Agricultural Benefit Statement

Park Farm, Malthouse Lane, Caerleon, Newport, NP18 3PB

Updated 22nd March 2022 (M. Stacey) following RFI.

Subject: PAN-016983 Request for information

3. Storage of wastes

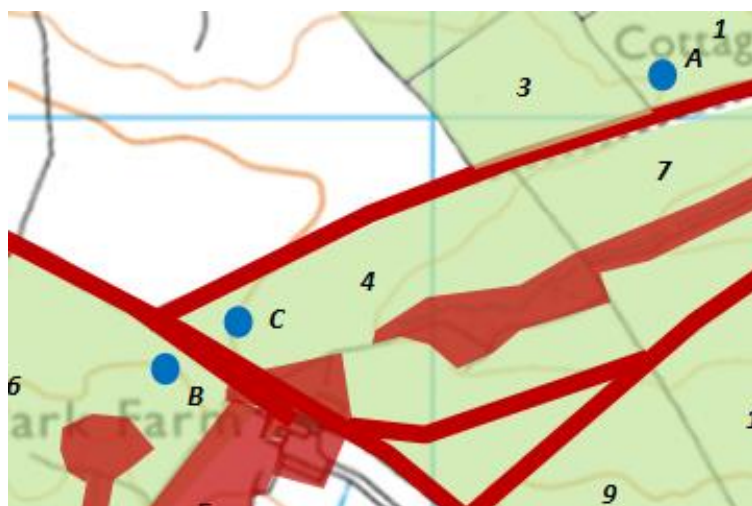
The storage on your application has been classed as field heaps, the location of these field heaps is the same as a deployment on these fields last year (PAN-011693).

The Water Resources (Control of Agricultural Pollution) (Wales) Regulations 2021 (and previously The Nitrate Pollution Prevention (Wales) Regulations 2013 (NVZ rules)) does not allow temporary field heaps to be:

- (a) in a field liable to flooding or becoming waterlogged,
- (b) within 50 metres of a borehole, spring or well or within 10 metres of surface water or a land drain (other than a sealed impermeable pipe),
- (c) located in any single position for more than 12 consecutive months, or
- (d) located in the same place as an earlier one constructed within the last two years.

ACTION: Please relocate these field heaps to a compliant location.

The storage locations provided have been re-located to suitable locations. This is illustrated on the below diagram and also updated within the spreading map and Benefit Statement.

4. Field Slopes

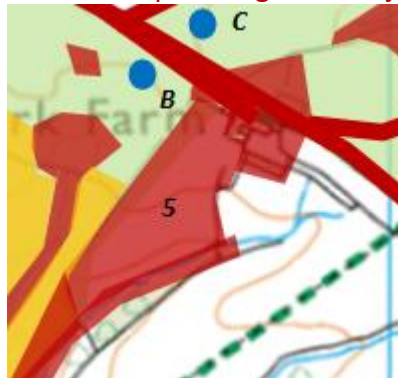
Fields 5, 6, 8, 10 and 11 have areas of slope of 12 degrees or steeper and areas of yellow slope indicating a slope between 7 and 12 degrees of gradient as indicated in

red and yellow respectively on the map attached for information. TGN 8.01 states that waste should not be applied on steep slopes where run-off is a high risk (TGN 8.01-Box 2.1.7a). The following areas are of particular concern:

- Field 5 is mostly red and has several water courses in the field, this is a clear impact pathway for waste entering or leeching into a watercourse.
Removed from deployment
- A section of field 6 also has a slope into a watercourse. **Acted on below.**
- The southern portion of field 11 also slopes into a SINC. **Acted on below.**
The eastern edge of field 11 and western area of field 10 also slope into a watercourse showing a clear runoff risk.
Acted on below.

- 2) Amend spreading maps to include non-spreading zones for the areas of steepest slope marked as red in fields 6,10 and 11 as there is a clear risk of runoff into a protected feature.

- 3) Please justify spreading on and give details of how you will mitigate the risks of spreading on the lesser sloping (yellow) areas in fields 6,8,10 and 11.

- 1) Remove field 5 from your application due to the very high run off risk into the water course. **This field has been removed from the deployment. Charts 6-10 in the ABS have been updated and total spreading areas adjusted accordingly.**

The no spread (red) steep areas on the contour map have been expanded to account for the areas of steeper gradient to be protective of the features on the spreading map. Thanks for bringing these to our attention. I will also provide a copy of your EA gradient topographic map in our contractors pack to add further granular detail.

These have been highlighted on the spreading map in Yellow. Spreading will be carried out using a trailing shoe and/or dribble bar to prevent liquid runoff and allow sub-surface penetration of wastes. In addition, in line with CoGAP:

- **No more than 50m³/ha will be applied to prevent high spreading rate flow and eliminate runoff.**
- **The material will only be applied at times when nutrient demand is required by the grass crop (late Feb – April and after silage cutting in summer/autumn).**
- **Slopes will be inspected frequently for signs of run-off collection during and after spreading.**
